March 22, 2013

**RE: PETITION FOR MODIFICATION AND TRANSFER OF THE POWER PLANT SITE CERTIFICATION,
CEMEX CONSTRUCTION MATERIALS FLORIDA, LLC SOUTH CEMENT PLANT'S STEAM
ELECTRIC GENERATING PLANT (PA-82-17); AMENDMENT OF PETITION**

Text, Figure, and Appendix Modifications to the Petition for Modification and Transfer

PROJECT		FLORIDA POWER DEVELOPMENT, LLC BIOMASS CONVERSION																				
TITLE		PROPOSED GRADING PLAN																				
MICHAEL H. SCOTT, P.E. FL PE NO. 72475 GOLDER ASSOCIATES INC. FL CA NO. 1670 5100 W. LEMON ST SUITE 208 TAMPA, FL 33609

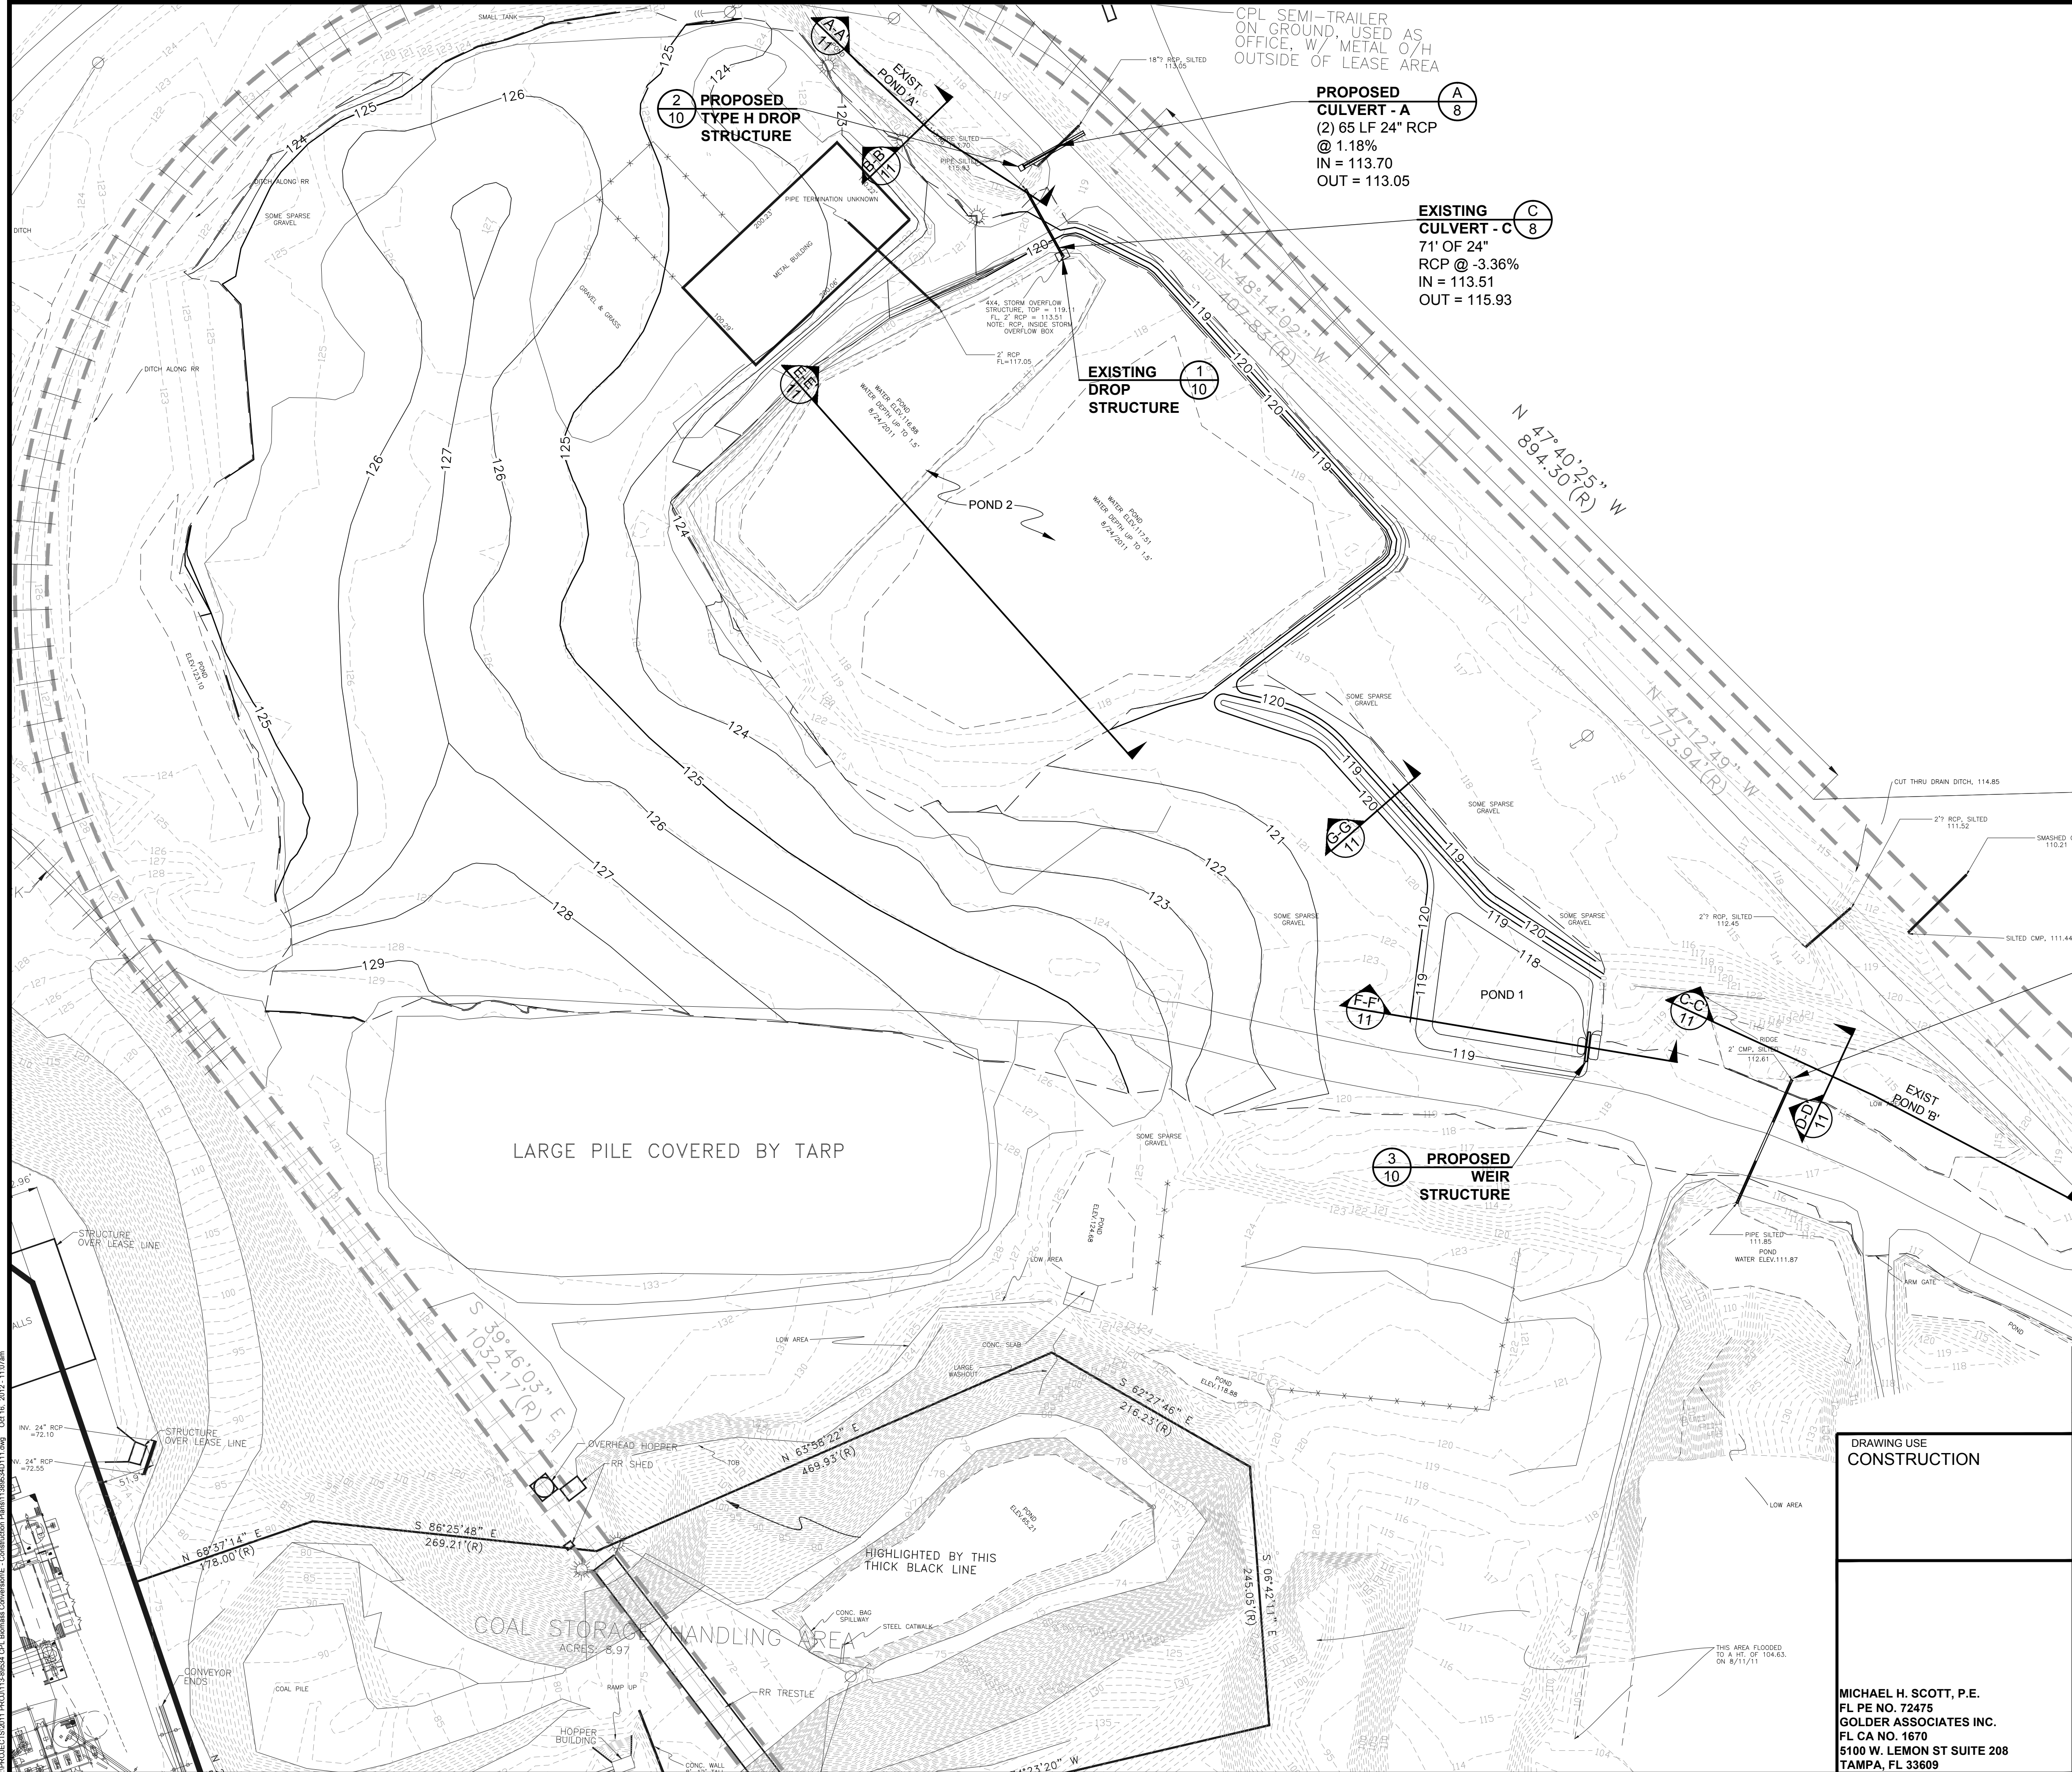
Sheet 06 Post Development Drainage Plan	Boundary and Site Acreage
	Sheet 07 Post Development Drainage Plan	Boundary and Site Acreage
	Sheet 12 Traffic Plan	Boundary and Site Acreage
	Attachment D- Topography and Wetland Survey	Boundary and Site Acreage
Appendix 8.7.6	Site Survey	Boundary and Site Acreage
